# Access Compliance Report

## Public Rights-of-Way

Intersection ID: 27363	Main Street: REA_RD	Cross Street: BALLANTYNE_COMMONS_PY	Location: SE
ADA ID: 85718400A38A	Ramp Type: ParaDiag	Initial Pass/Fail: Fail	Overall Compliance: No
Severity Score: 37.5			
Codes/Mitigation Info/Possible Solution		Field Measurements/Component Compliance

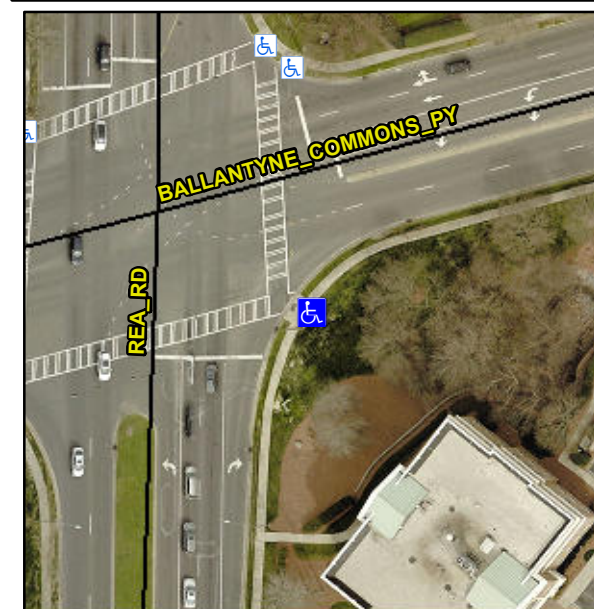
**R304.3.2, R304.5.3**

Compliance	Description	Data	Compliance	Description	Data
N/A	Ramp Length LT (in)	66.0	N/A	Ramp Length RT (in)	68.0
Yes	Ramp Width LT (in)	107.0	Yes	Ramp Width RT (in)	106.0
No	Ramp Slope LT (%)	8.6	No	Ramp Slope RT (%)	8.4
No	Ramp XSlope LT (%)	7.3	Yes	Ramp XSlope RT (%)	2.0
N/A	Landing Length (in)	N/A	N/A	DWS Provided?	N/A
N/A	Landing Width (in)	N/A	N/A	DWS Contrast?	N/A
N/A	Landing Slope (%)	N/A	N/A	DWS Length (in)	N/A
N/A	Landing X Slope (%)	N/A	N/A	DWS Full Width?	N/A
N/A	Landing Curb? (Y/N)	N/A	N/A	DWS Offset (in)	N/A
N/A	Shared Landing?	N/A			
N/A	Gutter Ponding?	N/A	N/A	Gutter Slope (%)	N/A
N/A	Gutter Lip Ht (in)	N/A	N/A	Gutter X Slope (%)	N/A
N/A	Painted X Walk1?	Yes	N/A	Painted X Walk2?	Yes
	X Walk 1 Direction	To N		X Walk 2 Direction	To W
N/A	X Walk 1 Width (in)	120.0	N/A	X Walk 2 Width (in)	119.0
	X Walk 1 Slope (%)	2.1		X Walk 2 Slope (%)	2.5
	X Walk 1 X Slope (%)	1.1		X Walk 2 X Slope (%)	0.6
N/A	Ramp inside XWalk1?	Yes	N/A	Ramp inside XWalk2?	Yes

**Remove & Replace Curb Ramp With Two New Directional Ramps or Equivalent.**
